Final Report - Corrections Required **Application No. DEPN-24-0160**

Description : Multi-family development with 170 rental duplex units on one development lot. Also a request for alternate landscape compliance related to placement of streamside overly and property boundary buffer plantings, and to be allowed to provide 9.4% active open space where 10% is required.

Document Filename : Cottages at Kettle Creek DP_1st_Submittal_101524.pdf

COTTAGES AT KETTLE CREEK

COTTAGES AT KETTLE CREEK PRELIMINARY UTILITY & PUBLIC FACILITIES PLAN

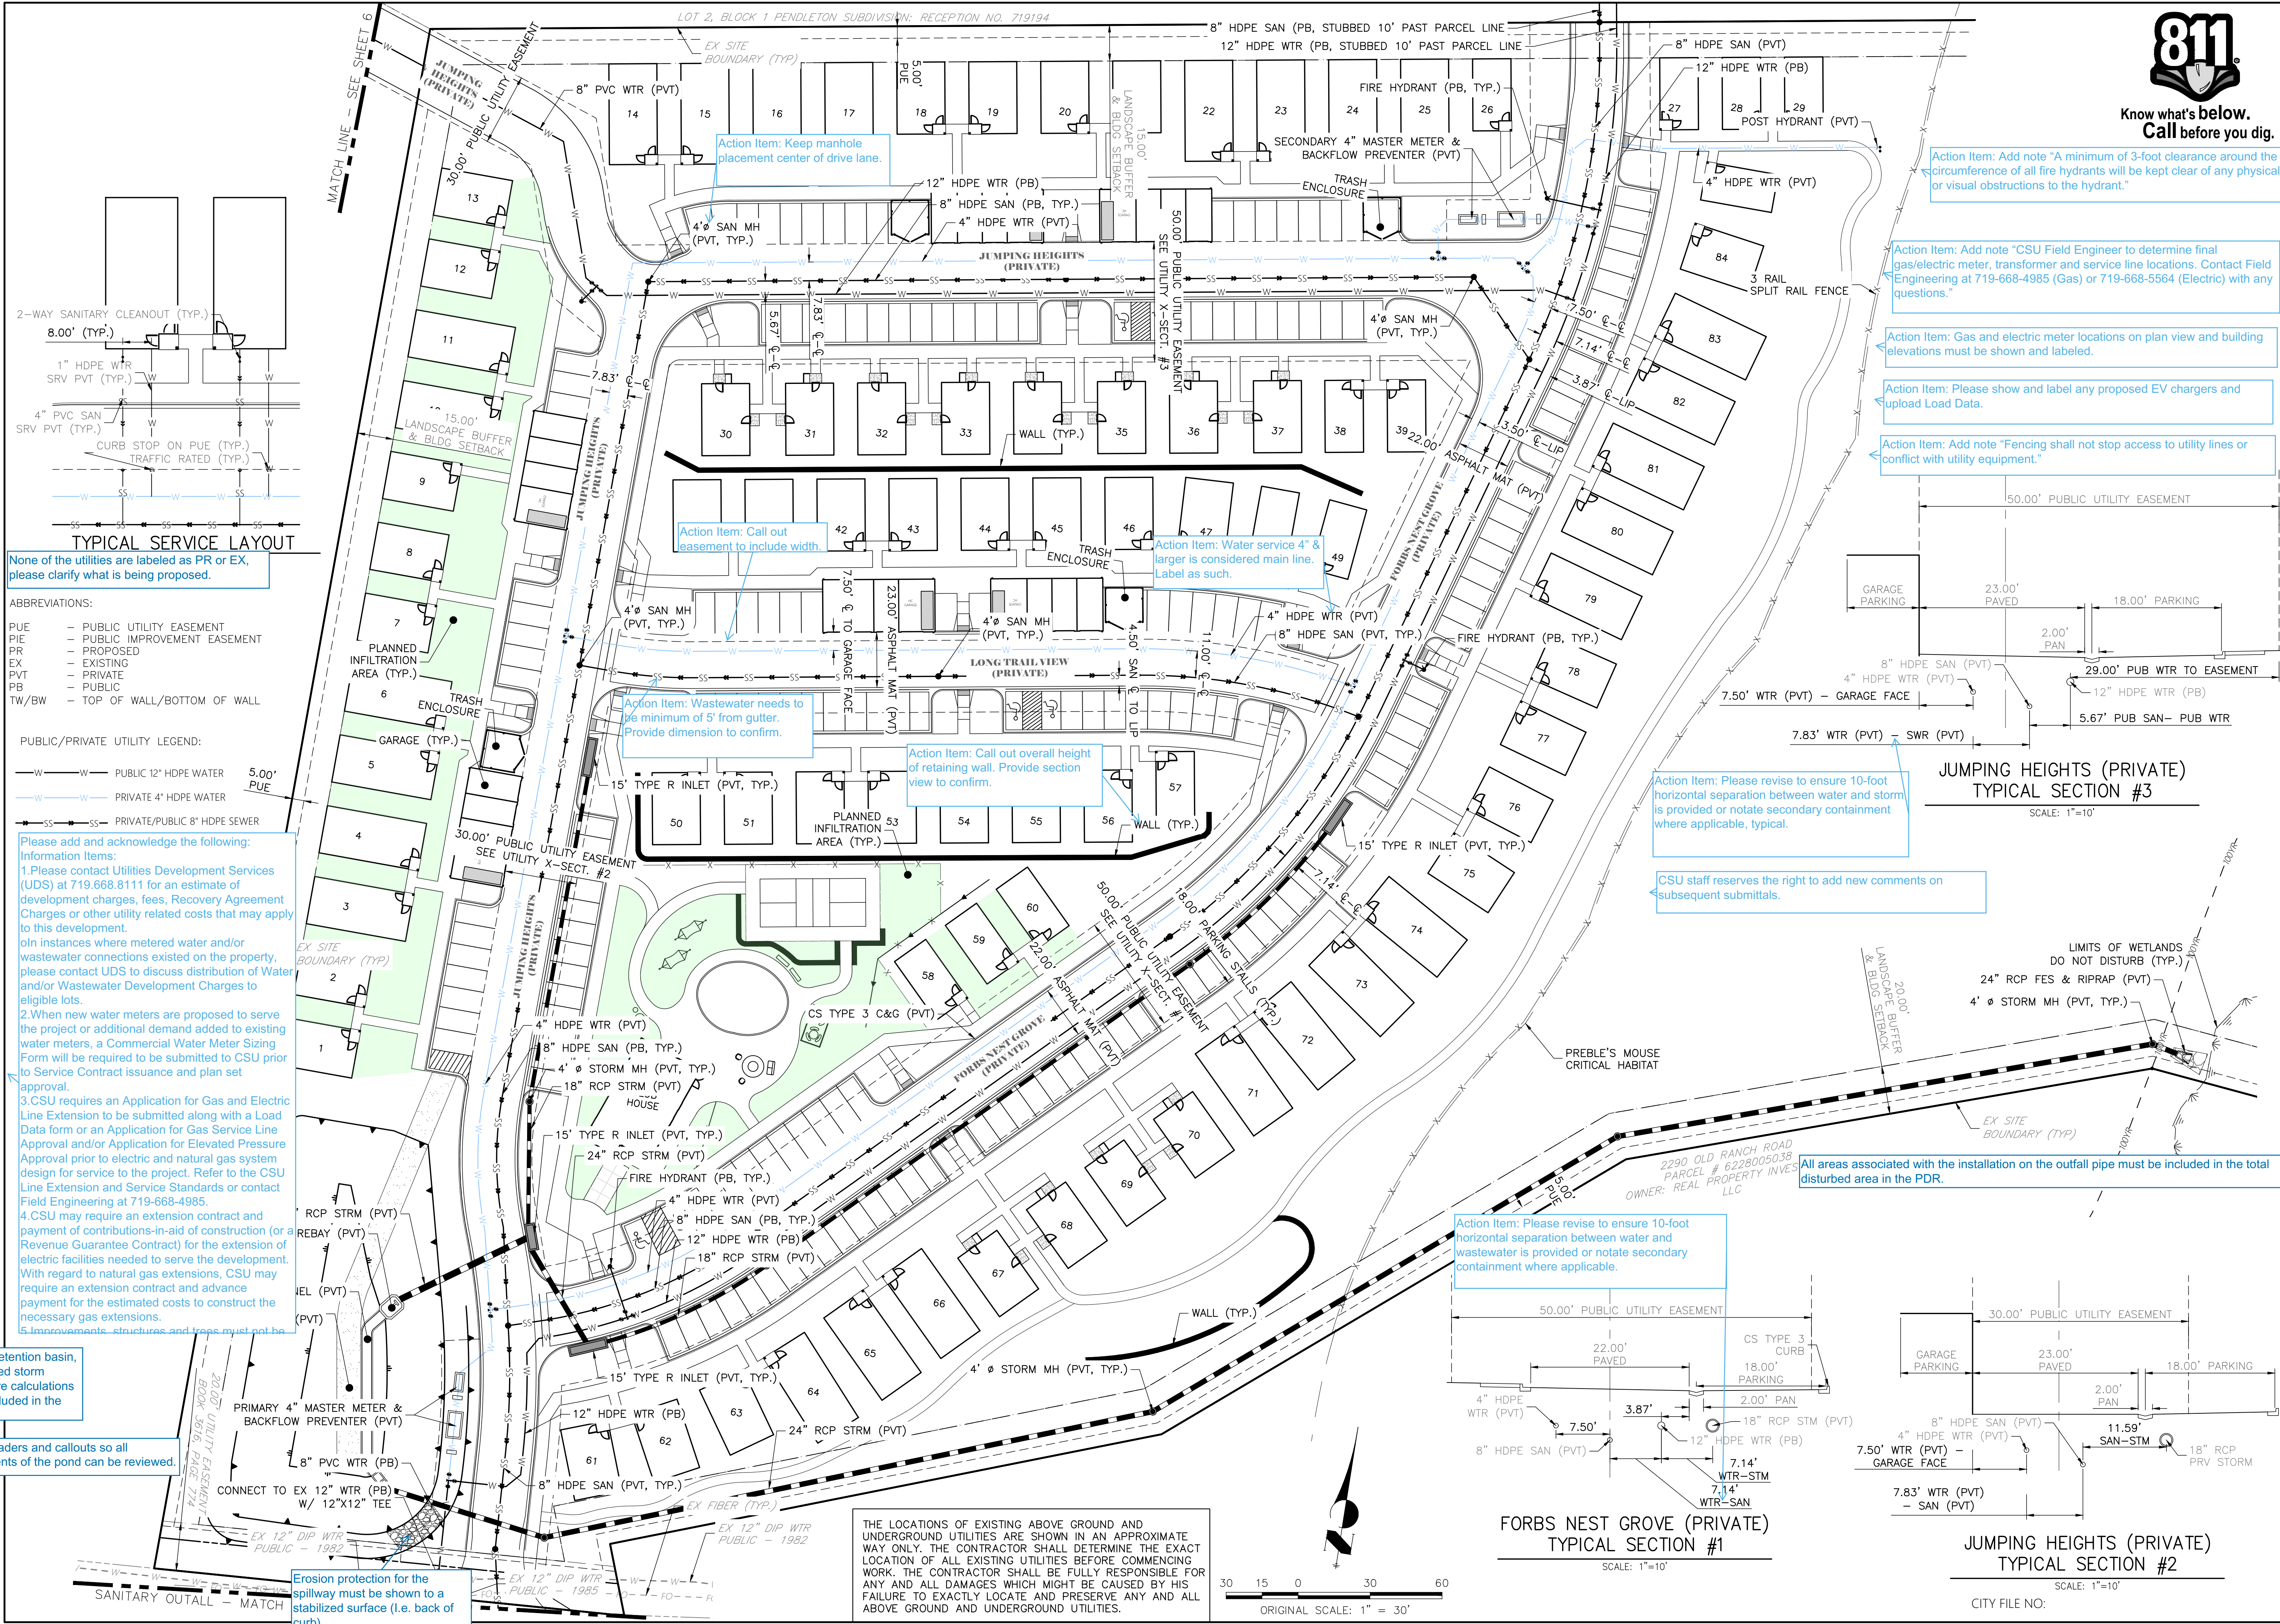
None of the utilities are labeled as PR or EX, please clarify what is being proposed.

Please add and acknowledge the following: Information Items: 1. Please contact Utilities Development Services (UDS) at 719.668.8111 for an estimate of development charges, fees, Recovery Agreement Charges or other utility related costs that may apply to this development. 2. When new water meters are proposed to serve the project or additional demand added to existing water meters, a Commercial Water Meter Sizing Form will be required to be submitted to CSU prior to Service Contract issuance and plan set approval. 3. CSU requires an Application for Gas and Electric Line Extension to be submitted along with a Load Data form or an Application for Gas Service Line Approval and/or Application for Elevated Pressure Approval prior to electric and natural gas system design for service to the project. Refer to the CSU Line Extension and Service Standards or contact Field Engineering at 719-668-4985. 4. CSU may require an extension contract and payment of contributions-in-aid of construction (or a Revenue Guarantee Contract) for the extension of electric facilities needed to serve the development. With regard to natural gas extensions, CSU may require an extension contract and advance payment for the estimated costs to construct the necessary gas extensions. 5. Improvements, structures and traps must not be

Action Item: Wastewater needs to be minimum of 5' from gutter. Provide dimension to confirm.

Action Item: Call out overall height of retaining wall. Provide section view to confirm.

Action Item: Please revise to ensure 10-foot horizontal separation between water and storm is provided or notate secondary containment where applicable, typical.

Action Item: Please revise to ensure 10-foot horizontal separation between water and wastewater is provided or notate secondary containment where applicable.

All areas associated with the installation on the outfall pipe must be included in the total disturbed area in the PDR.

PRELIMINARY LANDSCAPE PLAN

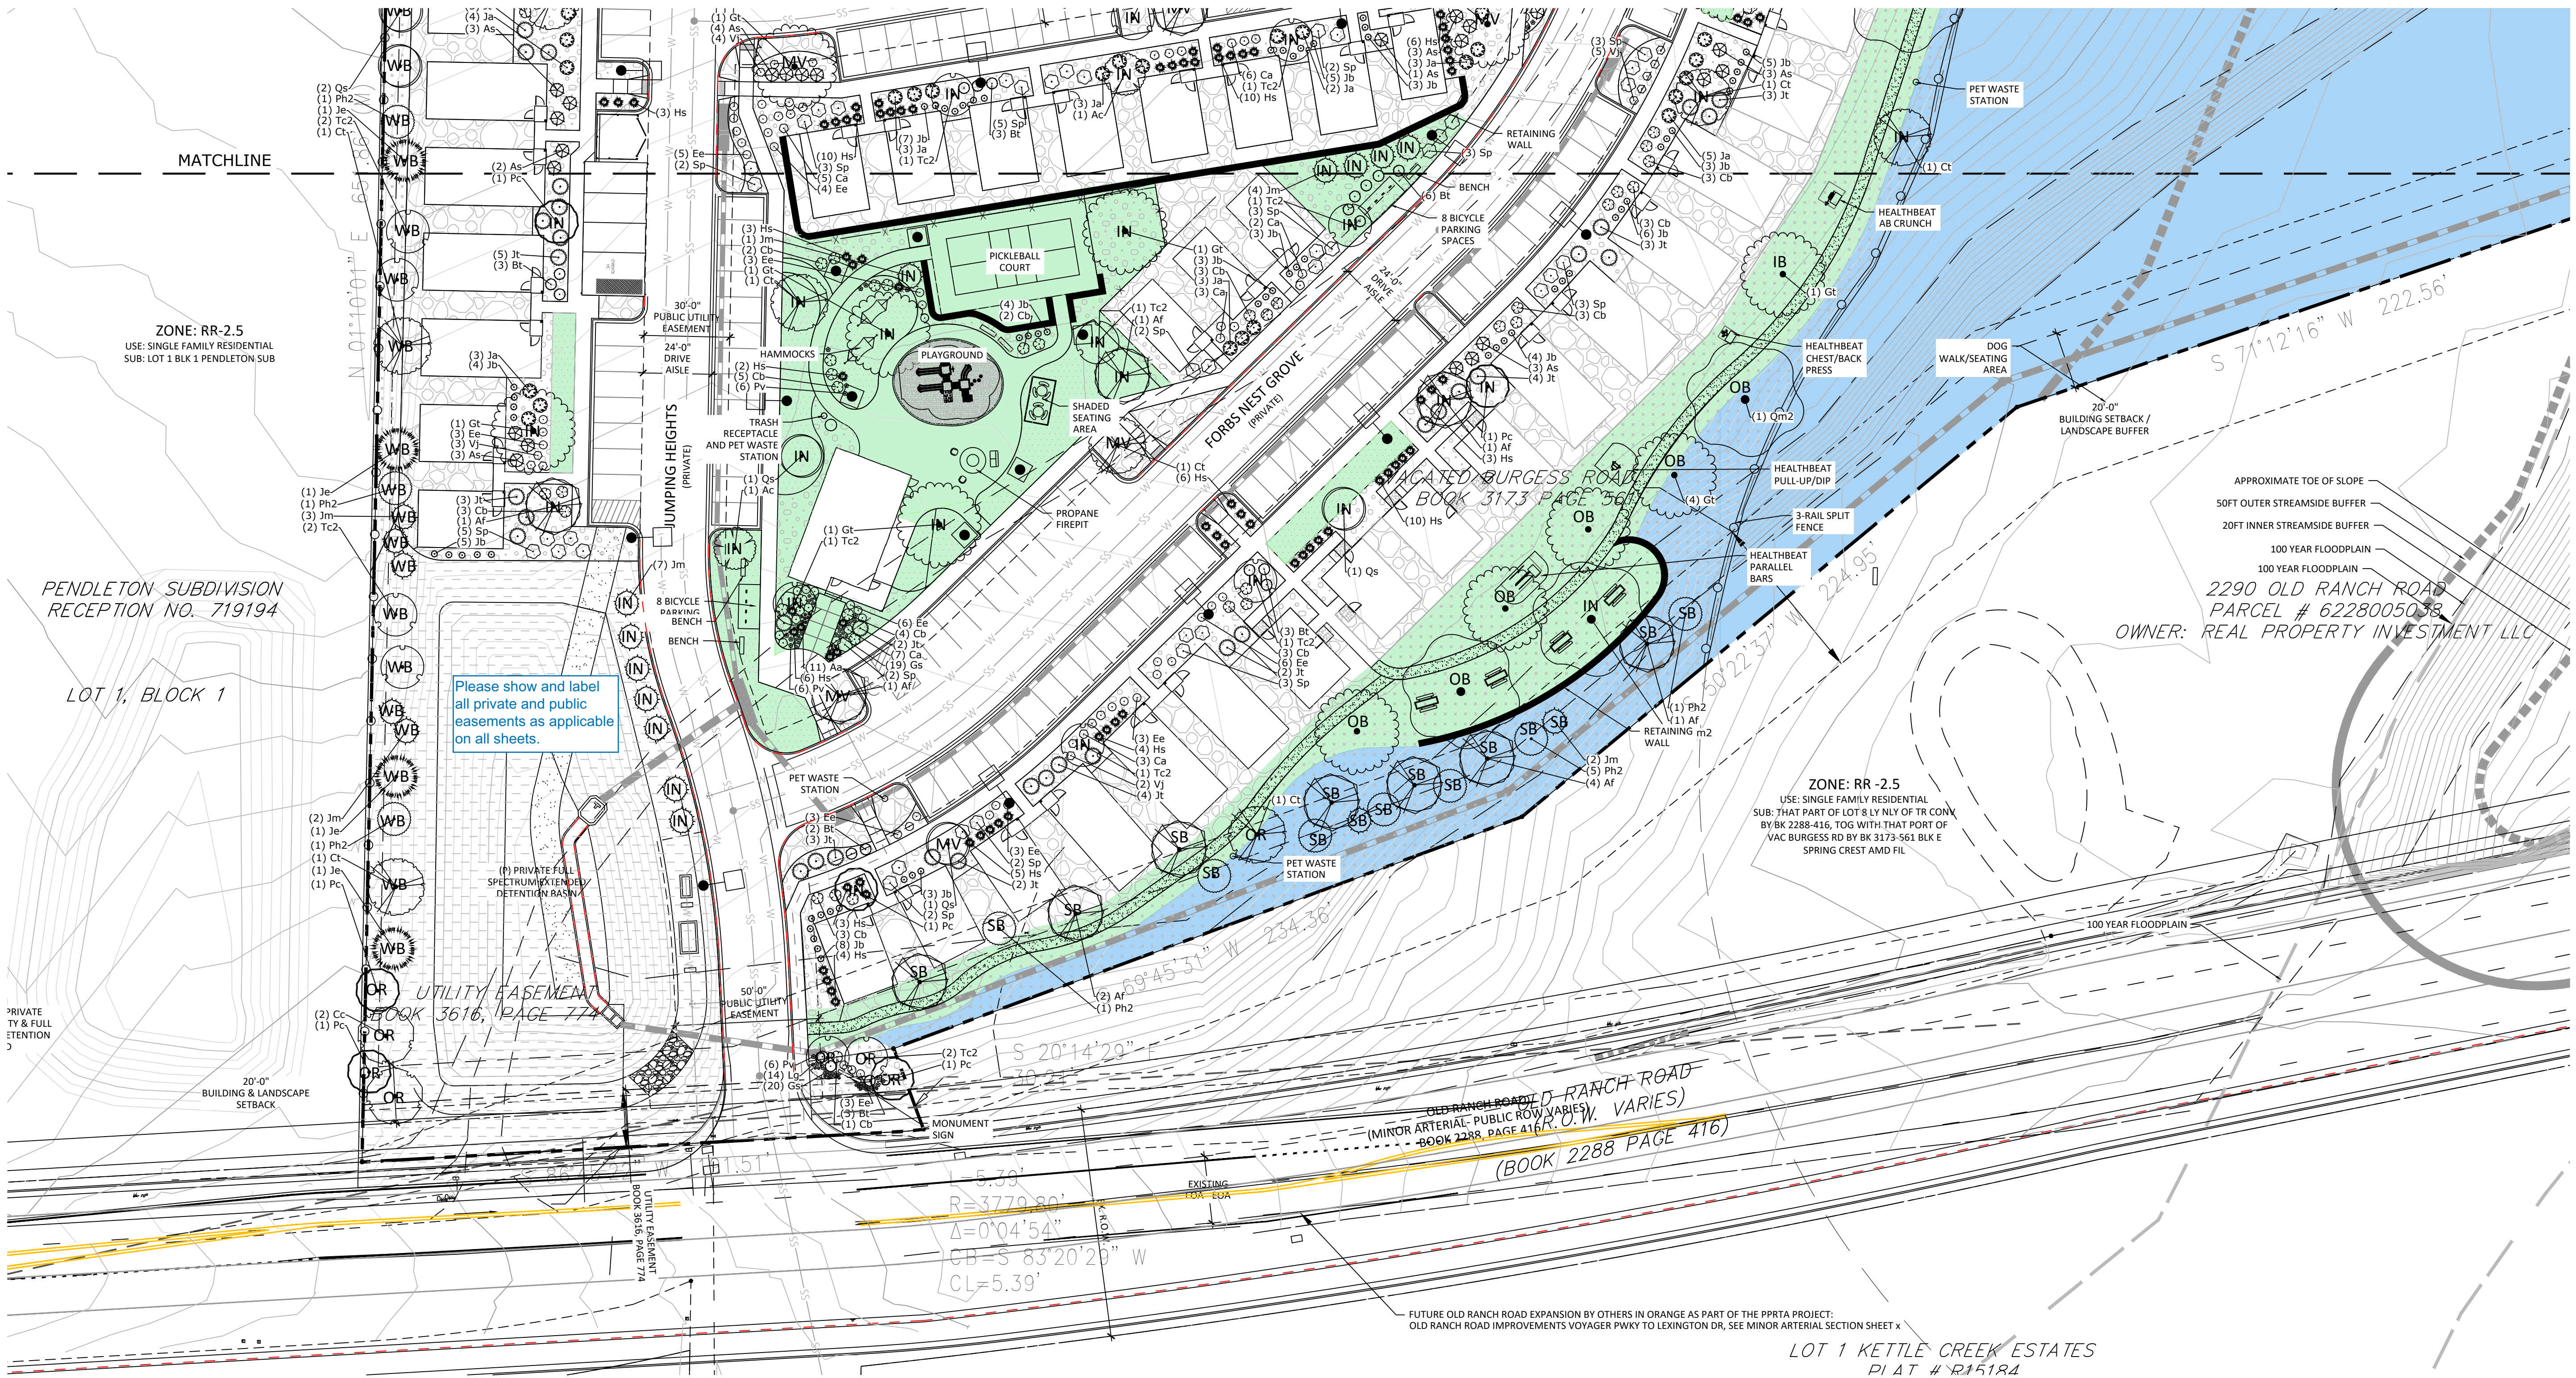
Ensure this matches the plans.

Action Item: Correct scale to 1" = 30'
